ADMINISTRATIVE DESIGN REVIEW RECOMMENDATION PACKET #3026875

3959 - 3965 FREMONT AVE N
January 30, 2020

NEIMAN TABER

figure d2

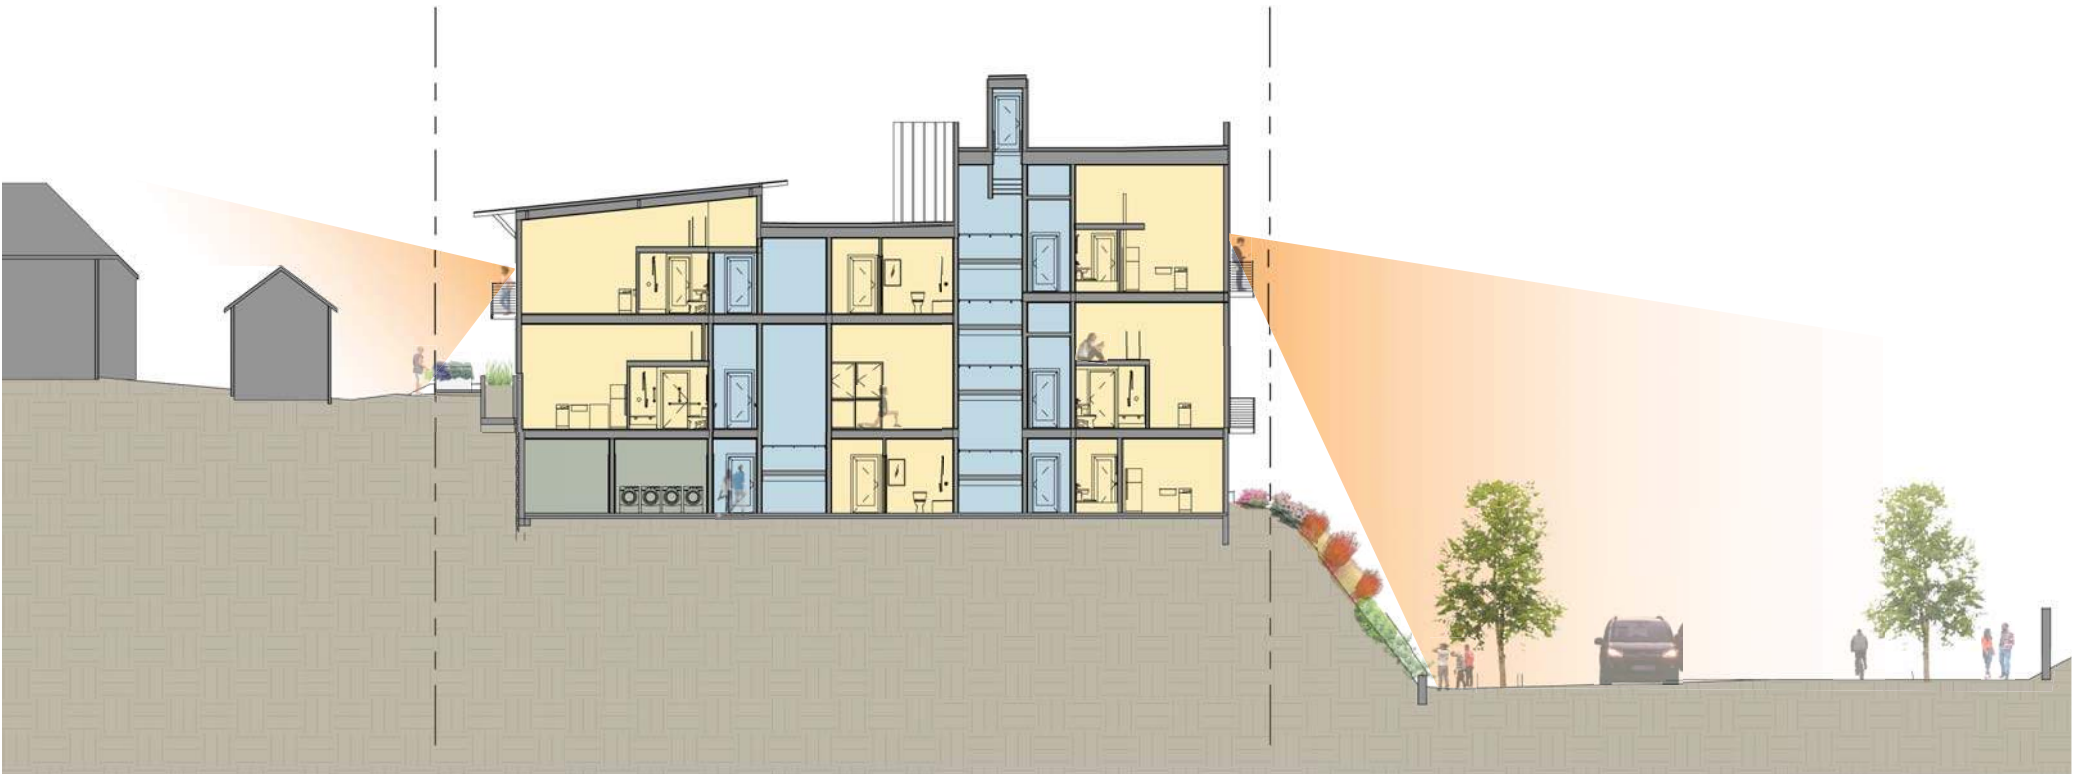
a. Further reduce the height, bulk, and scale of the building on the alley façade.

b. The single roof line creates too much bulk. Create a smaller scale building with lower and more traditional roof forms similar to those which predominate the neighborhood such as low and high-pitched roof forms which characterize the alley buildings.

The basic massing of the project has been organized to move height and bulk away from the alley side of the project. The building at the alley is only two stories tall. To further mitigate perceived mass of the structure along the alley, the slope of the roof of the west structure has been reversed to slope down toward the west (see figure d2).

The massing as illustrated is relatively low in scale and perceived bulk. Reversing the direction of slope of the roof significantly reduces the perceived scale of the project along the alley. The roof of the west portion of the structure has been maintained as a single slope in order to maintain a clear and compatible relationship with the rest of the project structure. We are attempting to design a building with an overall coherent design aesthetic that is modified and accented along the west side with additional elements that gesture toward the step down in scale and use from multi-family to single-family (see figure d2).

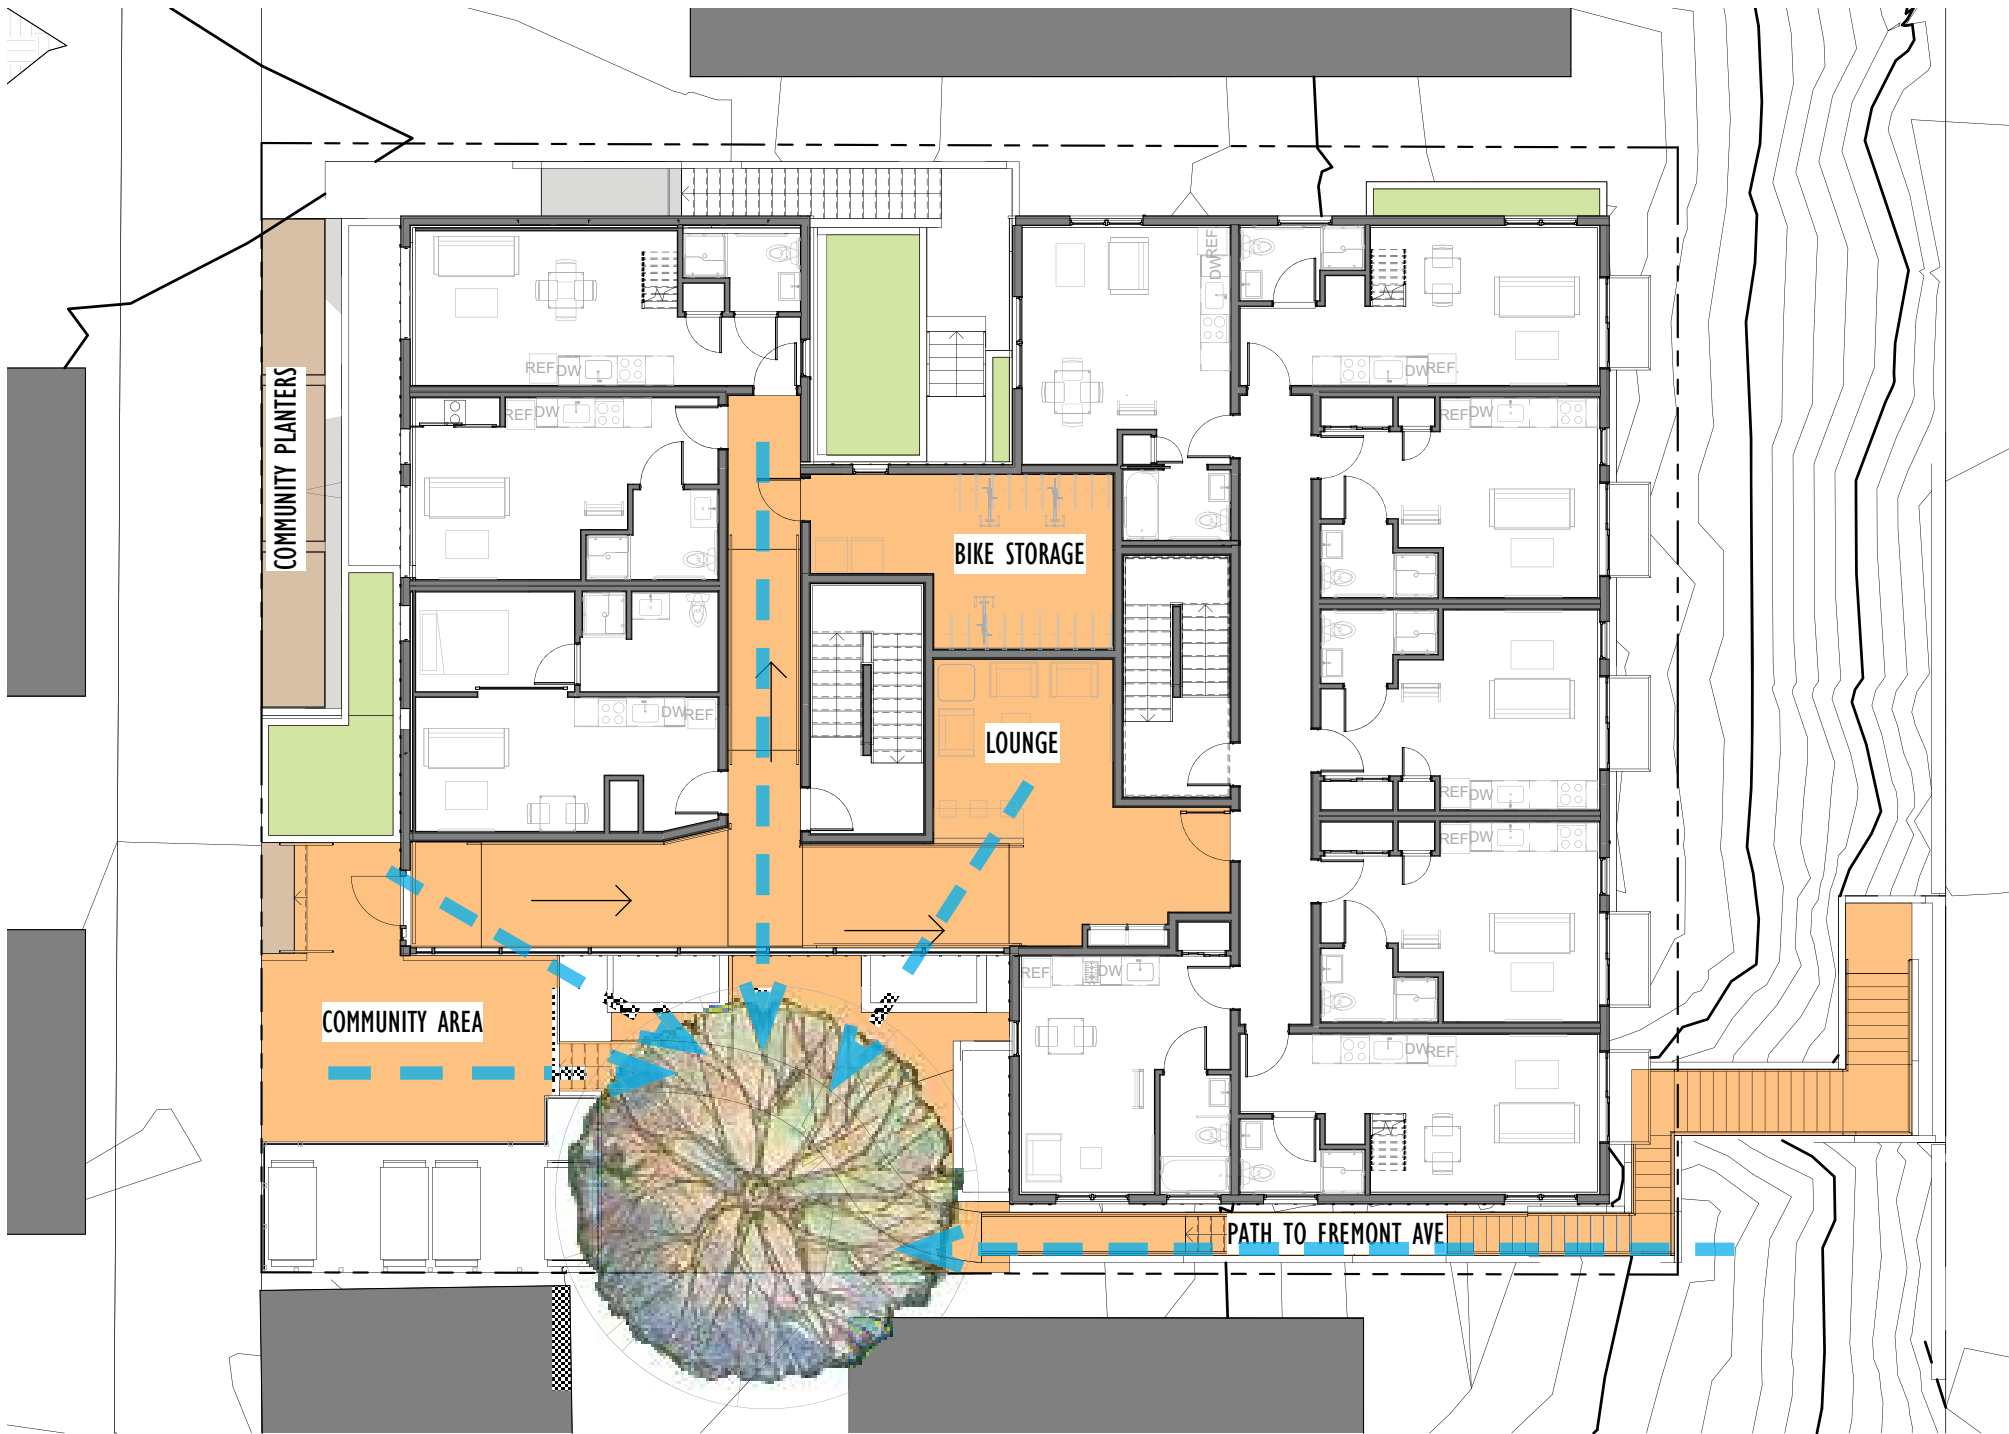
j. Reduce the scale of the east building to provide a quality entry experience and welcoming façade modulation. The entry should not feel like a tunnel entry, but more like a courtyard entry, compression is fine if there is an expansion of space a few steps away. Carve away the building to create an airy and welcoming forest edge entry. If possible, lower the building into the grade at the east façade.

The entry has been moved to the south of the project so that the entry path is visually connected to the tree courtyard. We have dropped the floor lines of the buildings as low as we can while preserving an accessible route into the building and throughout the main floor.

figure dep1

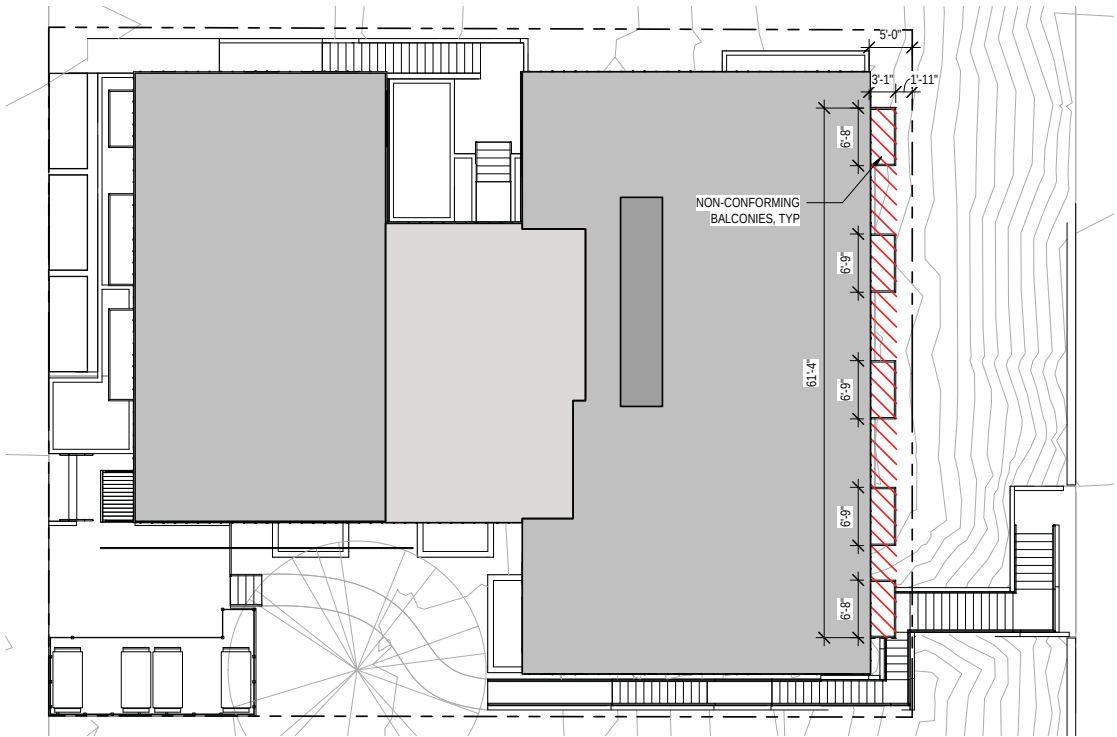
DEPARTURE #1

DEVELOPMENT STANDARD*	23.45.518.I1 - Setbacks and Separations
REQUIREMENTS	Unenclosed decks and balconies may project a maximum of 4 feet into required setbacks if each one is: <i>No closer than 5 feet to any lot line.</i>
PROPOSED	1'-10" balcony setback along East lot line
RELATED STANDARDS / GUIDELINES	DC3.A.1: Interior/Exterior Fit Balconies allow for the interior space to flow and relate to the exterior. DC3.C.2: Amenities and Features Allows for more activity along the facade of Fremont Ave. DC2.C.1: Visual Depth and Interest Creates depth and interest to the facade
DESIGN IMPOVEMENTS	The addition of balconies along the Fremont Ave facade provides a well balanced relationship between the building and the neighborhood, while also breaking up the mass and adding visual depth and interest. By increasing the amenity area and allowing the residents exterior space, we are also providing the opportunities for eyes on Fremont Ave, increasing security and the sense of safety.

figure dep2

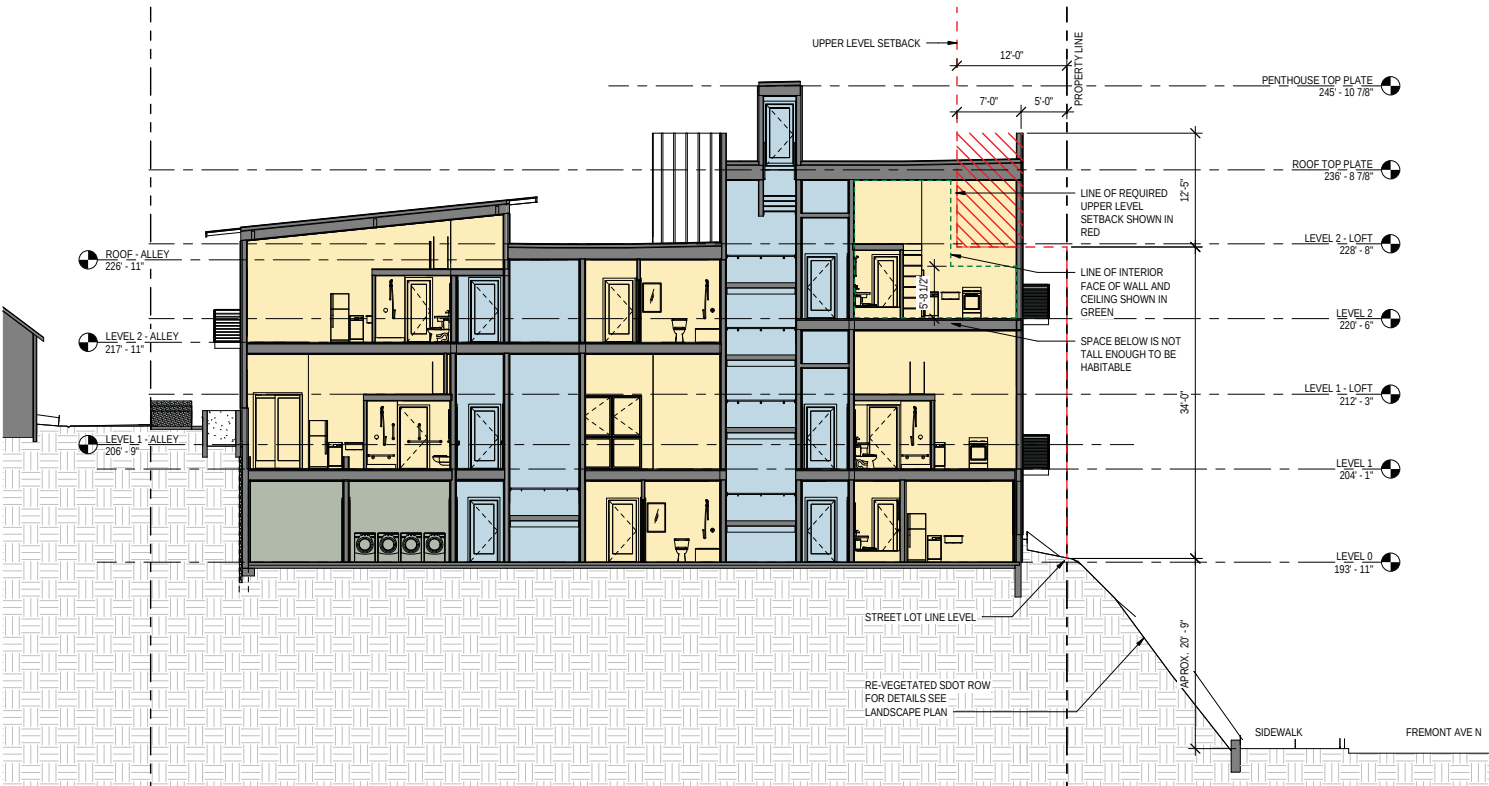
DEPARTURE #2

DEVELOPMENT STANDARD*	23.45.518.L1 -Setbacks and Separations
REQUIREMENTS	In LR zones, a minimum upper-level setback from all street lot lines is required in addition to any required ground-level setback, as follows: <i>For structures with a 30 foot height limit according to Table A for 23.45.514 the upper-level setback requirement is 12 feet above a height of 34 feet.</i>
PROPOSED	5' Upper-level setback to a street lot line
RELATED STANDARDS / GUIDELINES	CS2.A.2: Architectural Presence Adds articulation to the street facade and invites social interaction. CS3.A.3: Established Neighborhoods Creating a presence that relates to the existing surrounding buildings DC3.A.1: Interior/Exterior Fit Connects the interior and exterior, allowing tenants to interact with the outside
DESIGN IMPOVEMENTS	By encroaching on the upper-level setback we are creating a more coherent building mass that is keepig with the simple platonic building forms found throughout the neighborhood.

figure dep3

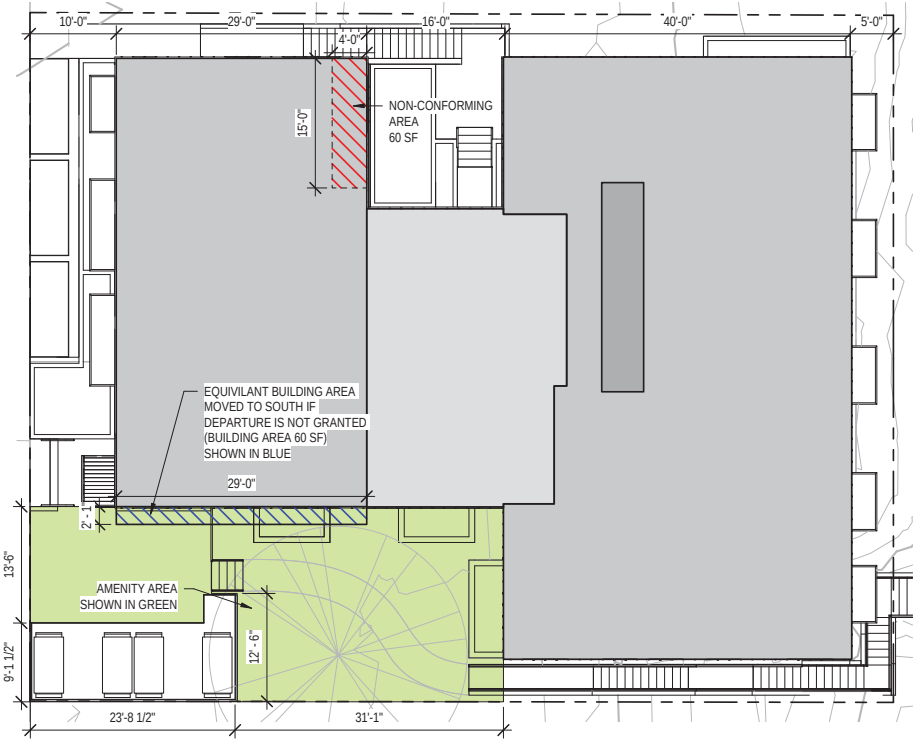
DEPARTURE #3

By relocating the 60SF of building from the southern facade to the north we allocating more space for the exceptional Japanese Maple and providing an area for ciruclation around the tree for residents to walk by and enjoy it's beauty.
